# UNITED STATES PATENT AND TRADEMARK OFFICE

APPLICATION NO.	FILING DATE	FIRST NAMED INVENTOR	ATTORNEY DOCKET NO.	CONFIRMATION NO.
10/730,456	12/08/2003	Robert G. Metzger	5490-000317	2923
27572 7590 01/30/2008 HARNESSE, DICKEY & PIERCE, P.L.C. P.O. BOX 828 BLOOMFIELD HILLS, MI 48303			EXAMINER SWIGER III, JAMES L	
			ART UNIT 3733	PAPER NUMBER
			MAIL DATE 01/30/2008	DELIVERY MODE PAPER

## Office Action Summary

Fig. 2.

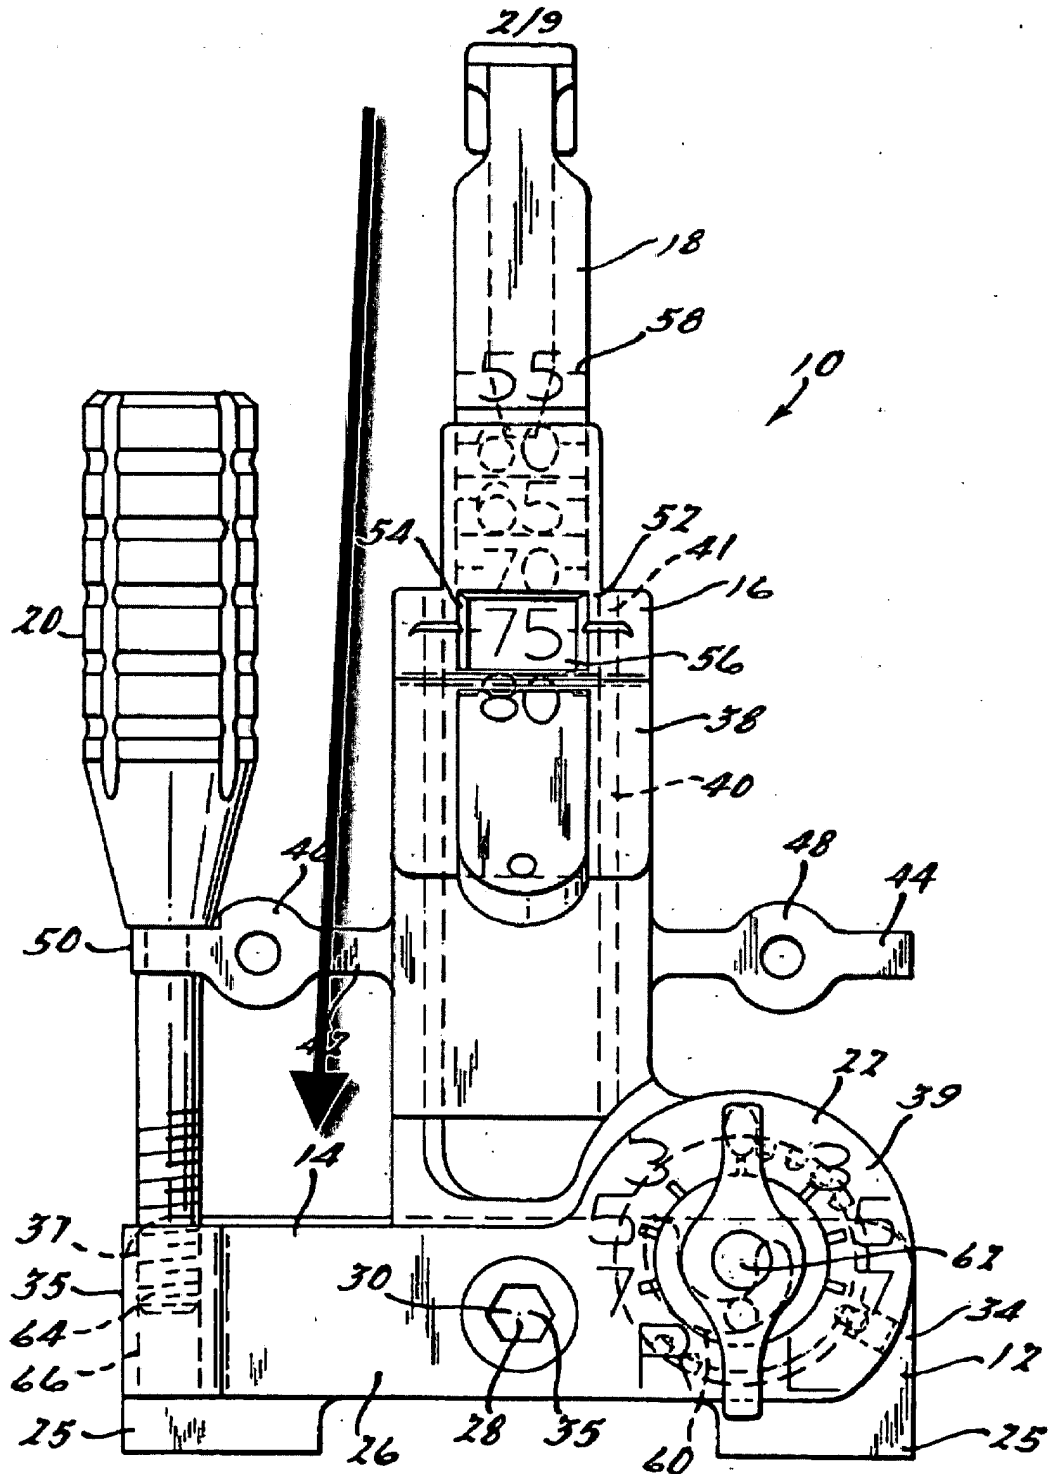
The drawings are objected to as failing to comply with 37 CFR 1.84(p)(4) because reference character "14" has been used to designate a base portion in Figs. 1 and Fig. 2. These are two separate portions denoting the same subject matter and is thus conflicting. See drawings below. Corrected drawing sheets in compliance with 37 CFR 1.121(d) are required in reply to the Office action to avoid abandonment of the application. Any amended replacement drawing sheet should include all of the figures appearing on the immediate prior version of the sheet, even if only one figure is being amended. Each drawing sheet submitted after the filing date of an application must be labeled in the top margin as either "Replacement Sheet" or "New Sheet" pursuant to 37 CFR 1.121(d). If the changes are not accepted by the examiner, the applicant will be notified and informed of any required corrective action in the next Office action. The objection to the drawings will not be held in abeyance.

Item 14 defined as base:

Item 14 defined as base:

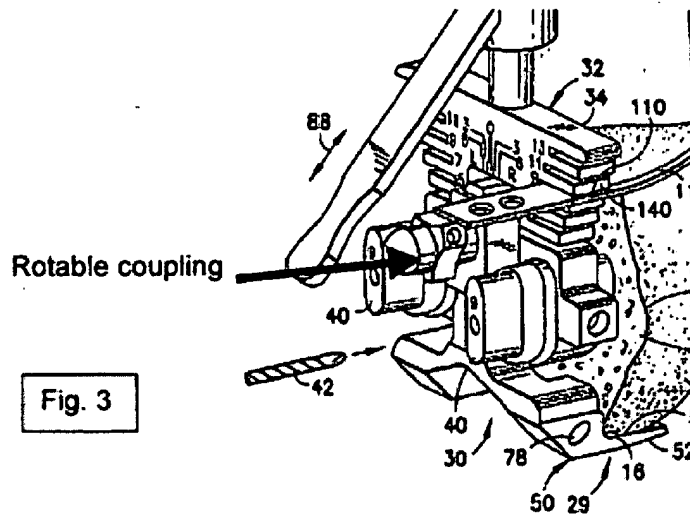
Claims 1, 8, 34, 36-37, and 41-42 are rejected under 35 U.S.C. 102(b) as being anticipated by Harwin et al. (US Patent 6,458,135). Harwin et al. disclose a femoral guide having an extension portion (30) configured to be adjacent to a posterior condyle surface to the femur, a base portion (32), a superstructure (90) and a graduated stylus (80) that is *configured* to be adjacent to the anterior condyle surface of the femur. It is further noted that language "configured to" has been held that performing a function is not a positive limitation but only requires the ability to perform. It does not constitute a limitation in any patentable sense. *In re Hutchison*, 69 USPQ 138. Harwin et al. further disclose a device with a pair of feet (52, the second foot hidden in Fig. 3), the extension is rotably coupled to the base (See Fig. 3 below)

Contrary to the arguments as disclosed by applicant on 7/24/2006, the Harwin reference DOES teach that the base may be rotably coupled to the base. Harwin discloses that 60 is a "pivotal connection" and further that the device includes (65) markings to better fit various angles. See also Fig. 2, lines 35-50). Further, the device of Harwin et al. disclose a slot to restrain the movement of the stylus (96) that is also capable of being rotably coupled and is substantially parallel.
